Re. New High School in Jerrabomberra SSD RFI
Our Ref. 5555

Reference is made to the response submissions from the Department of Planning, Industry and Environment (DPIE), - Queanbeyan - Palerang Regional Council and Transport for NSW (TfNSW) with respect to SSDA submission for the New High School in Jerrabomberra (Reference SSD – 24461956).

Table 1 DPIE RtS Letter

SEDIMENT AND EROSION CONTROL PLAN

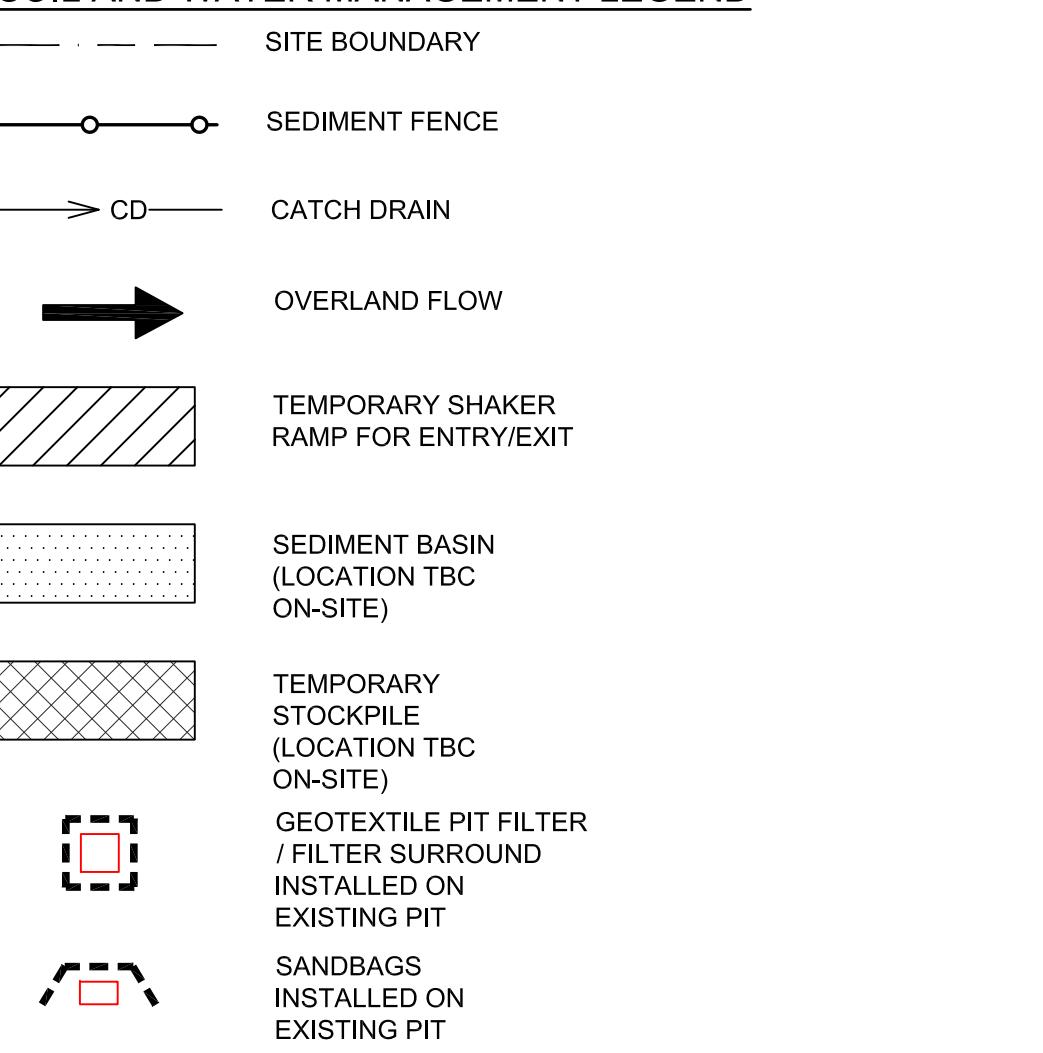
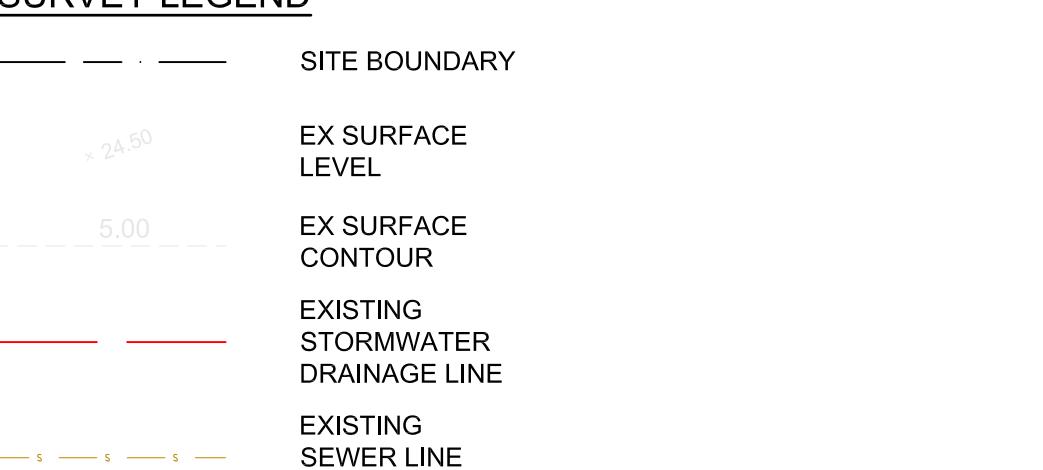
EPA – Appendix A	<p><u>Construction</u></p> <p>The EIS identifies that, prior to any earthworks commencing onsite, soil and water management control measures that comply with the Managing Urban Stormwater – Soils and Construction will need to be</p>	<p>A conceptual Soil & Water Management Plan (SWMP), in accordance with the “Blue Book” has been prepared and is detailed on M+G drawings JHS-CE-2005 & 2006, attached to this response in the Appendix A.</p>

<p>in place. The EPA acknowledges that a range of sediment and erosion control measures are discussed in the EIS, including the installation of a temporary sediment basin to capture site runoff. Details on the capacity, sizing, design rain event, catchment, and management of the sediment basin has not been provided. The EPA recommends further information to demonstrate the capacity, sizing, design rain event, catchment and management of the sediment be provided.</p> <p>The EPA recommends that a detailed Sediment and Erosion Control Management Plan is developed for the proposed construction prior to the commencement of works.</p>	<p>A detailed SWMP containing detailed design of the Sediment Control, Erosion Control and Site Stabilisation practices, including staging of the earthworks and these practices, will be prepared by the earthwork contractor and reviewed and approved by Hindmarsh/M+G prior to civil works commencing.</p> <p>This plan will include monitoring provisions that will allow the SWMP to be changed/modified during the works to ensure that the required Water Quality Objective are achieved during the construction stage.</p>

NOTE:
REFER DRAWING JHS-CE-2005 FOR SEDIMENT CONTROL DETAILS.
